NEWS Trailer

74592001e

Modification of the T-piece for AirSave

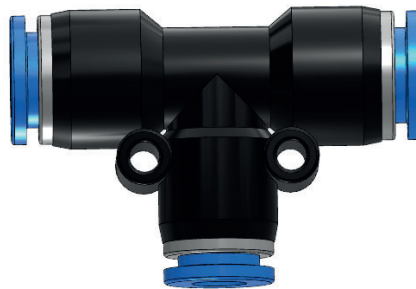
With immediate effect, the axle will be supplied with a modified T-piece. In future, the connection for the compressed air hose from the control box will have a connection with a diameter of 8 mm, instead of 6 mm as before.

Compressed air
hose of the axle:
6 mm

Compressed air
hose of the axle:
6 mm

Connection for the compressed
air hose of the control box:
8 mm

This enables the use of the standard dimensions of 8 mm of the compressed air hoses that are usually available.
